Office Action Summary

10/603,250

ULMAN, JOHN T.

DETAILED ACTION

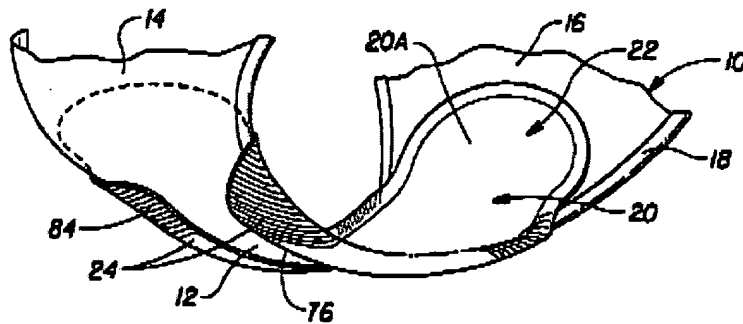
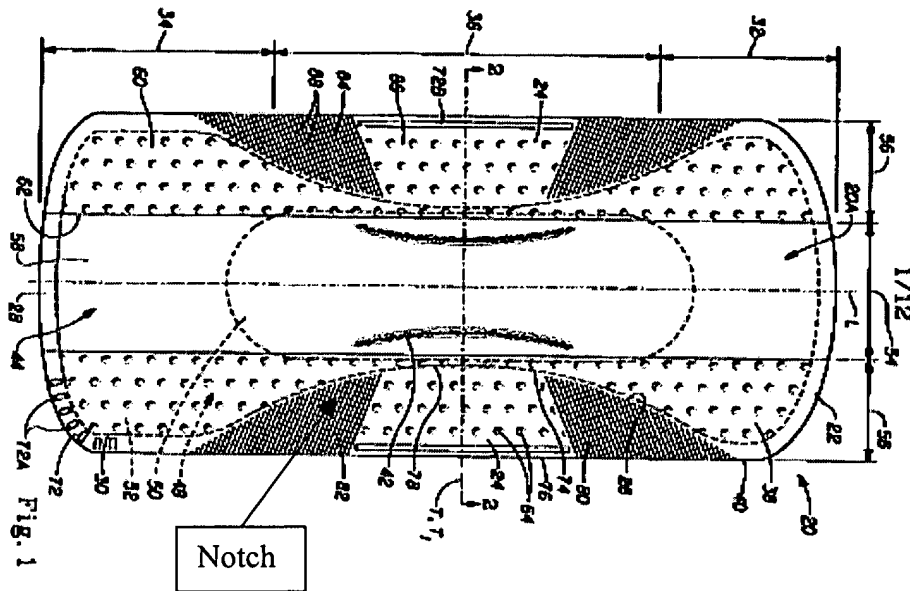
Regarding claim 17, Hines teaches a sanitary napkin (20) comprising:

a main body (22), the main body (22) comprising a fluid-permeable cover layer (44), a liquid-impervious barrier layer (46) and an absorbent system (48) intermediate the cover layer (44) and the barrier layer (46), wherein the main body (22) comprises a front portion (32), a rear portion (34) and a center portion (36) intermediate the front portion (32) and the rear portion (36), and wherein the front portion (32) extends laterally to at least one outermost front distal point (40) and the rear portion extends laterally outward to at least one outermost rear distal point (40); and

a side flap (24) projecting laterally outward from the absorbent system (48), extending laterally outward from a proximal edge (74) of the center portion (36) and capable of being folded over a crotch portion of a user's undergarment (10) in use, the side flap (24) extending laterally outward from the proximal edge (74) to a distal end (76), wherein the distal end (76) is not substantially laterally outward from the at least one outermost front distal point (40) and the distal end (76) is not substantially laterally outward from the at least one outermost rear distal point (40), and wherein the at least one outermost front distal point (40), the at least one outermost rear distal point (40), and the side flap (24) are each positioned on a single side of a longitudinally extending center line (L) of the sanitary napkin (20); and

a inherently resilient element (50), said resilient element (50) being separated from the flap by along a hinge line (78)(see figures 1 and 9, below).

Regarding claims 3 and 8, Hines teaches that the flap (24) is, at least in part, structurally isolated from the front portion (32) by an anterior notch, and the flap (24) is, at least in part, structurally isolated from the rear portion (34) by a posterior notch. As defined herein, the weakened material (84) within the notch makes the flap (24) partially structurally isolated from ends (32, 36). The asymmetric notches are defined as being more acute than 90° angle of the intersection between side flap (24) and proximal edge (74).

Regarding claim 4, Hines teaches that the side flap (24) projects outward to at least one outermost distal point (76) of the flap (24), and wherein the sanitary napkin (20) further comprises an anterior notch defined by an anterior notch boundary that extends continuously from the at least one outermost front distal points (40) to the at least one outermost distal points (76) of the flap (24), and wherein the at least one outermost distal points (76) of the flap (24) are located on the single side of the longitudinally-extending centerline (L)(see figure 1).

Regarding claim 5, Hines teaches that the anterior notch boundary includes portions that are laterally inward from the outermost front distal point (40)(figure 1).

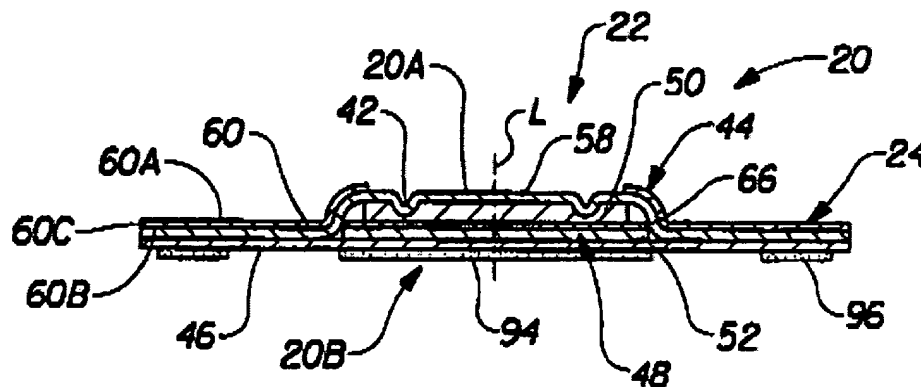
Regarding claim 7, Hines teaches a flap positioning adhesive (96) on the bottom surface of the liquid impervious barrier layer (46)(figure 2).

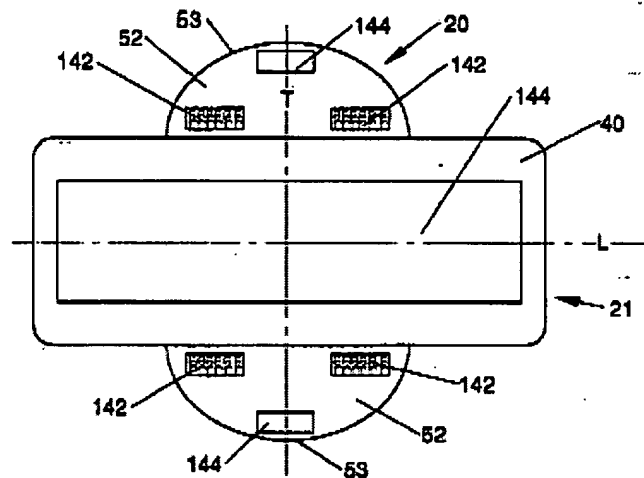
Hines does not provide specific dimensions for the notch depth or span.

Mere modification of the relative size of something in the prior art is not sufficient to patentably distinguish a claimed invention from the prior art.

In the instant case, the claimed dimensions do not appear to be critical, nor is there an unexpected result shown from these specific dimensions.
